## **S. Wasson Lane Reconstruction and Cascade Avenue Intersection Improvements**

**State Project No: 7994-00-49**

**Request for Proposals:  
Questions & Answers**

Issued: February 10, 2021

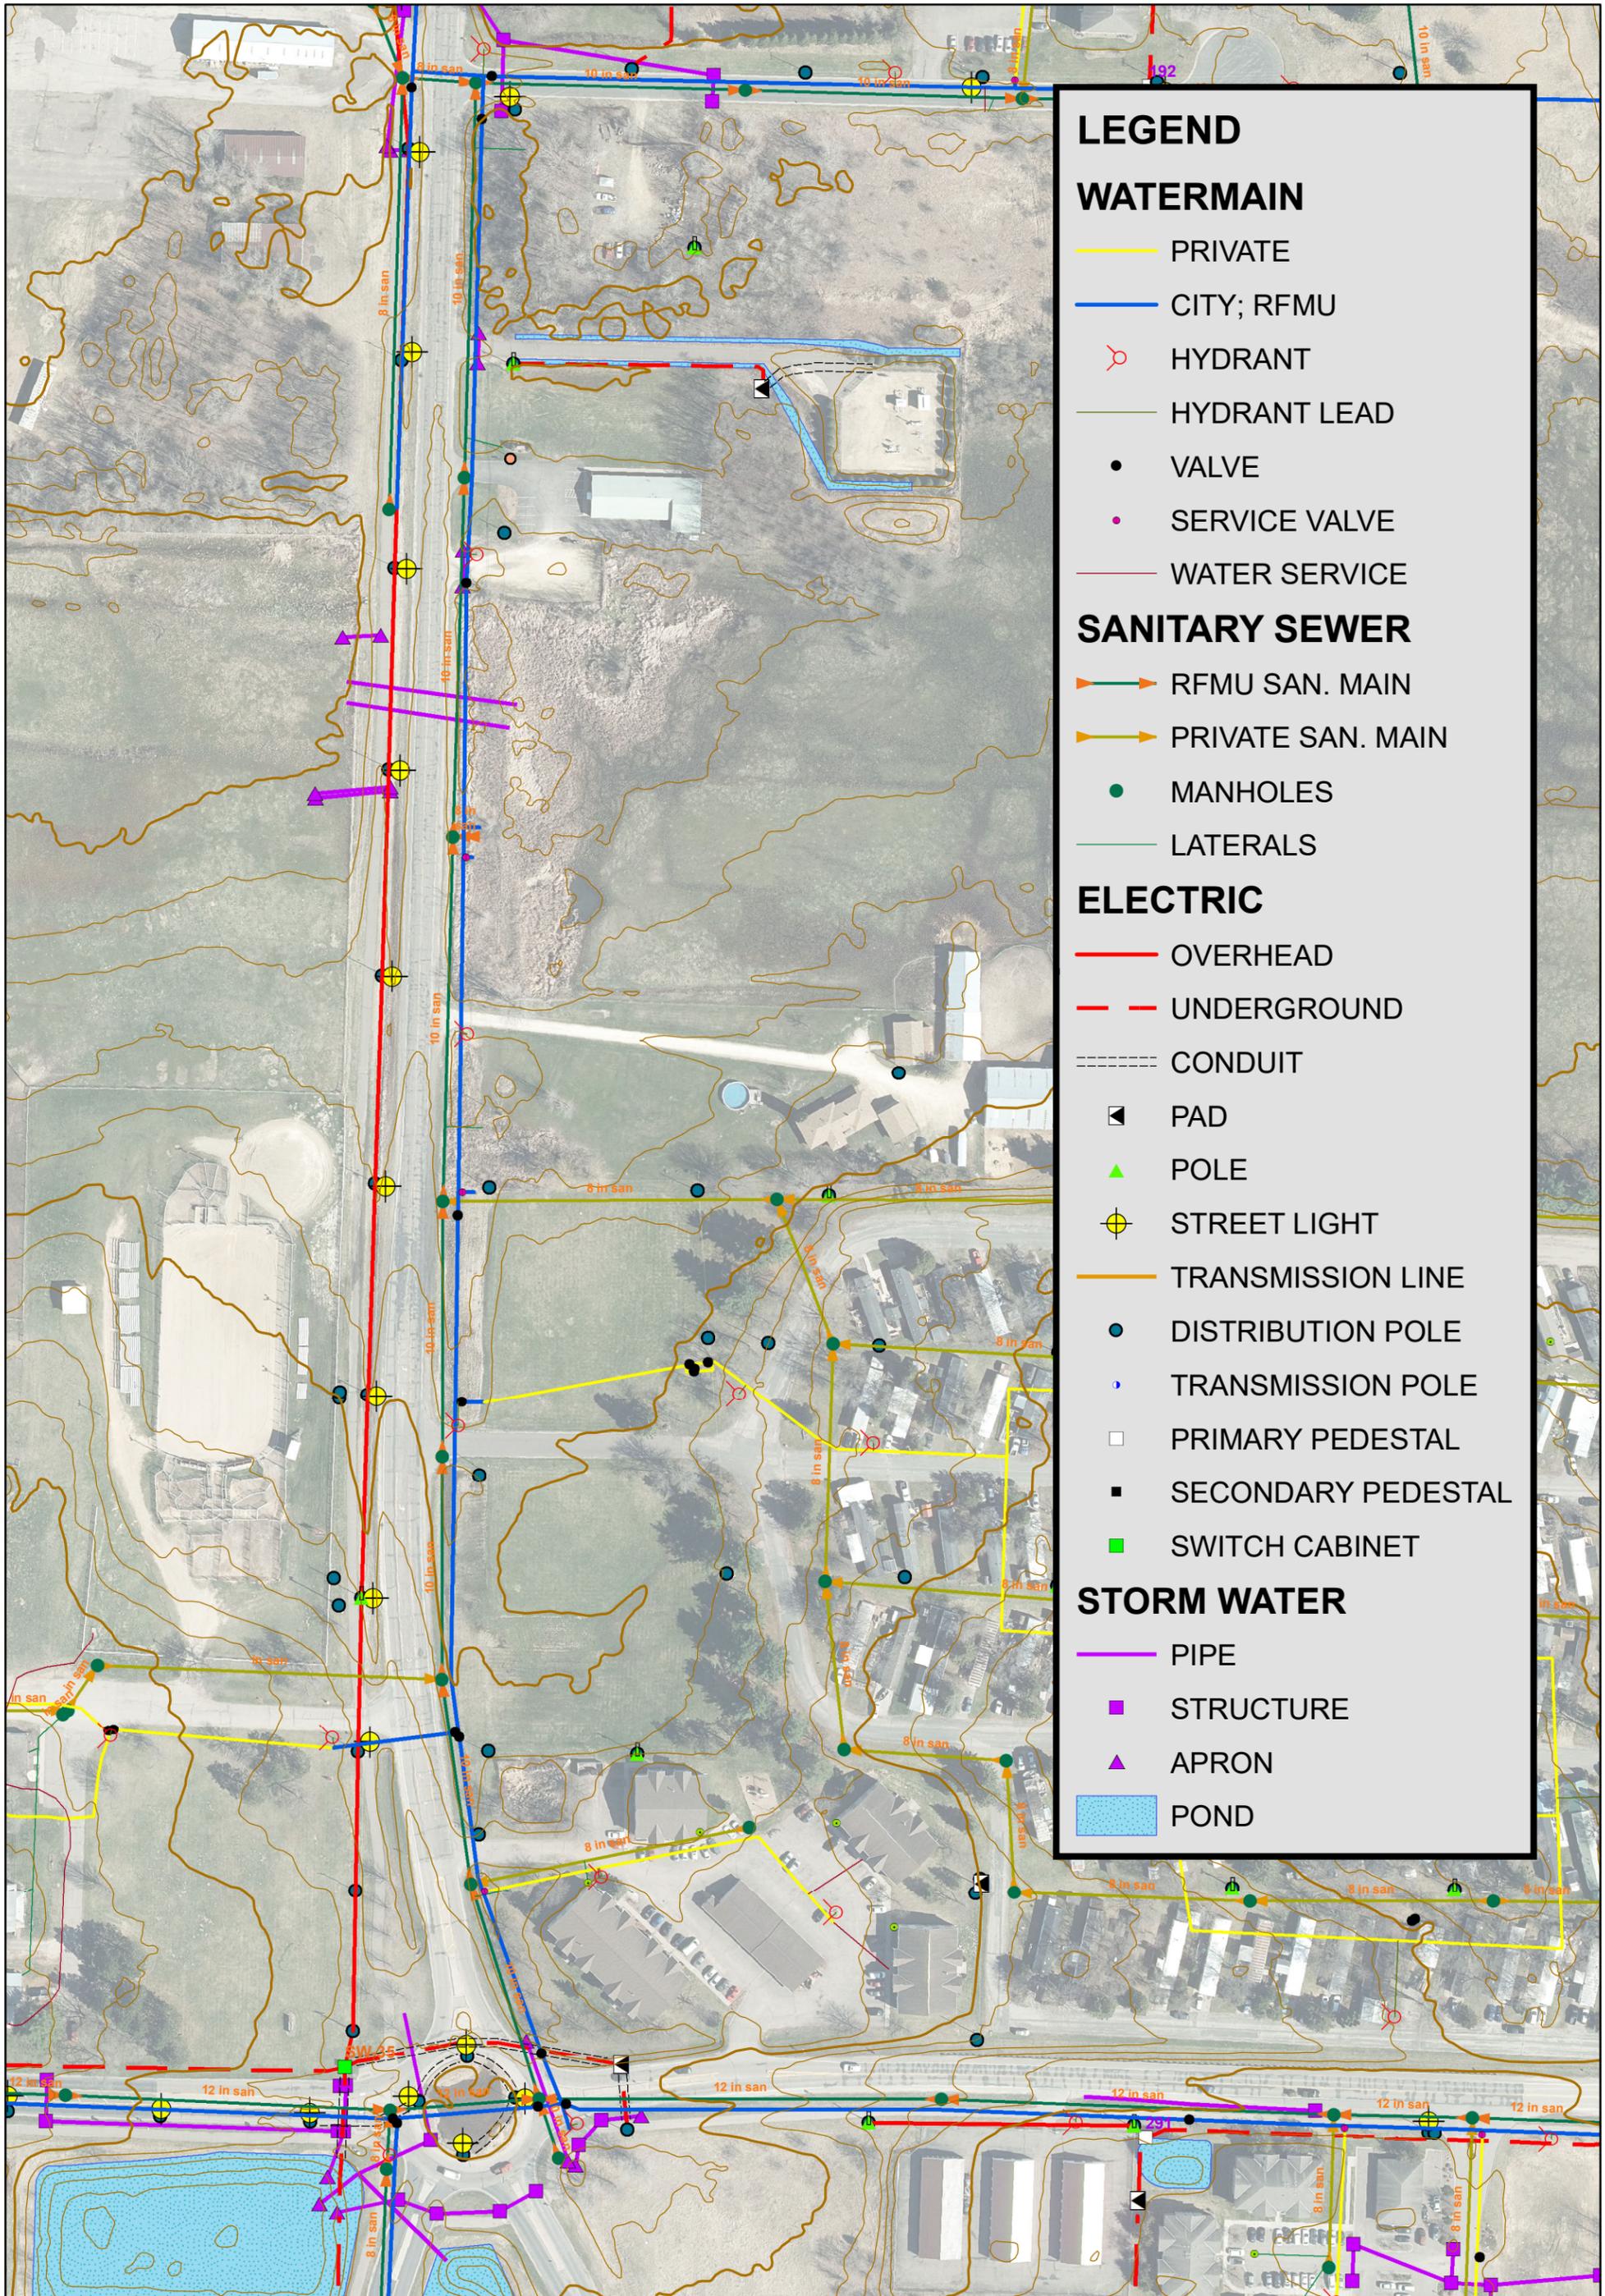
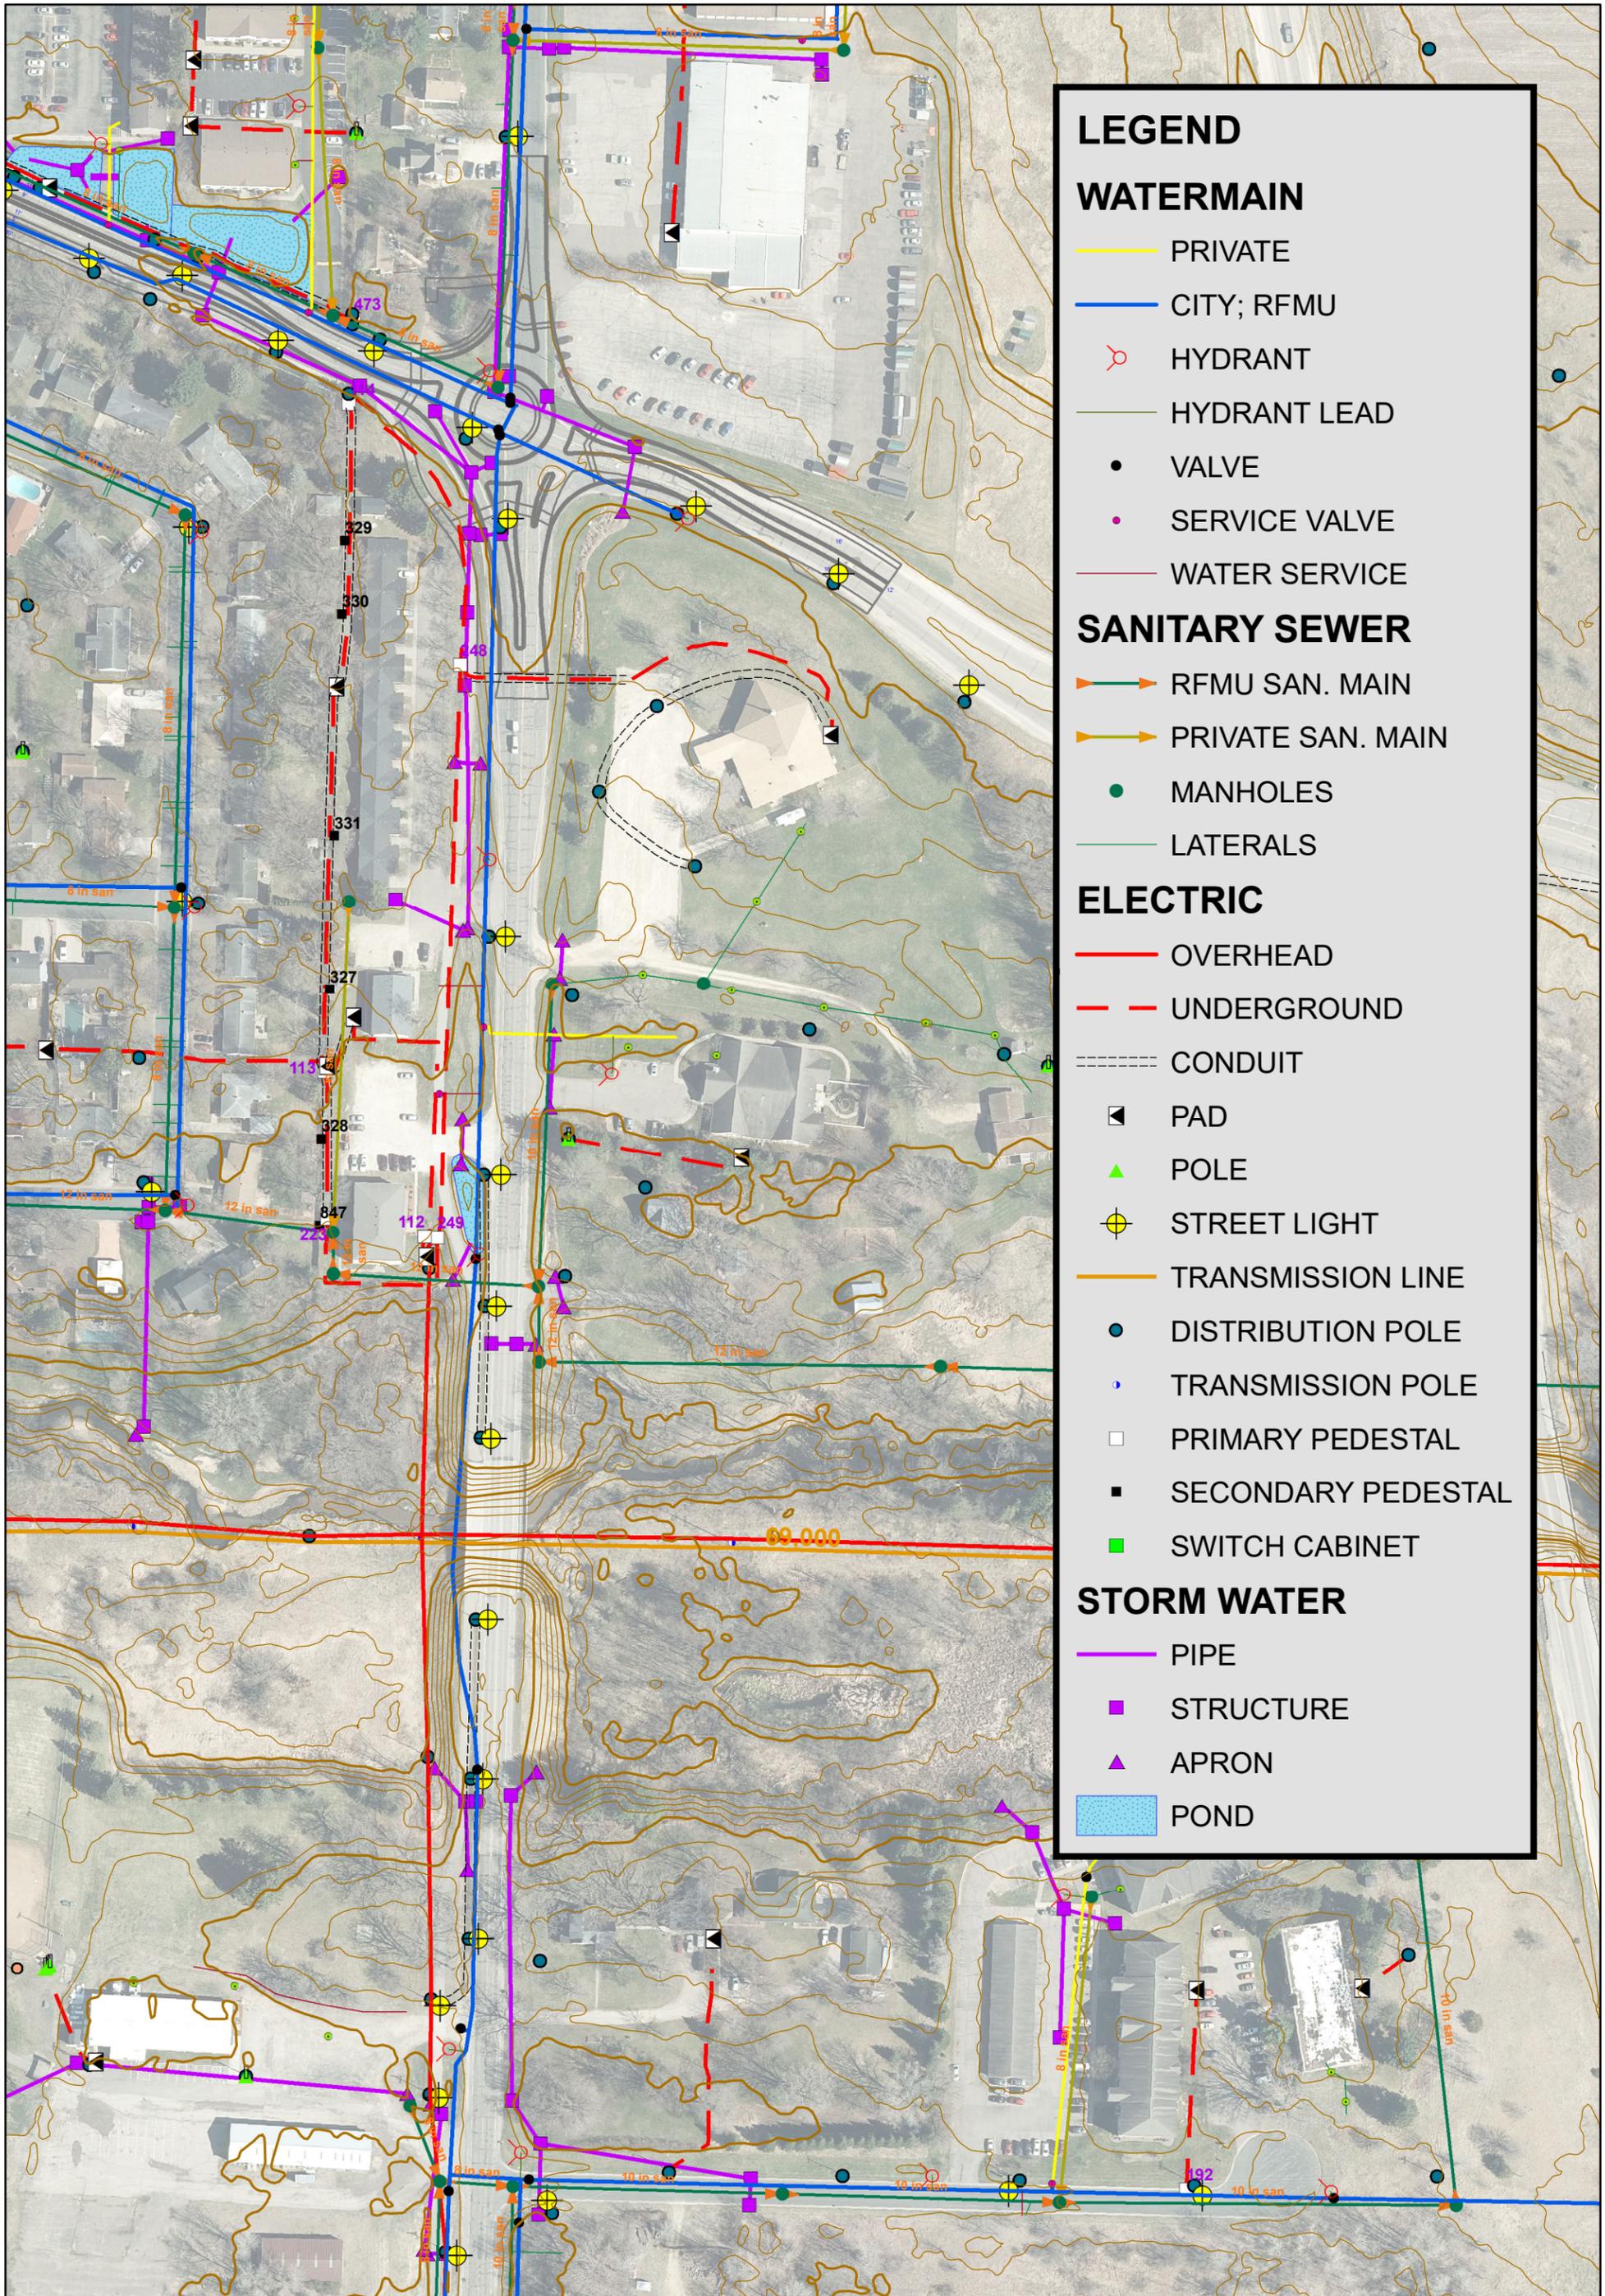
1. What is the age of the existing sewer and water through this corridor? Is there a need for replacement or upsizing?

Two plan sheets accompany this document that show utility configuration throughout the corridor. Most sewer and water infrastructure was installed in 1993. Outside of surface adjustments, there is no need to upsize or make significant changes to sewer and water infrastructure.

9. Can you further explain the overhead electric on the west side of the project?

RFMU owns and operates 3-phase overhead electric on the west side of the project per the attached maps. There is no desire by them to make significant changes to this infrastructure. Grade changes at the base of the pole of less than one foot will be relatively simple to accommodate. RFMU is also willing to make necessary changes to parts of the line if it can't be avoided. RFMU and the City will encourage the consultant to avoid major impacts to this line.
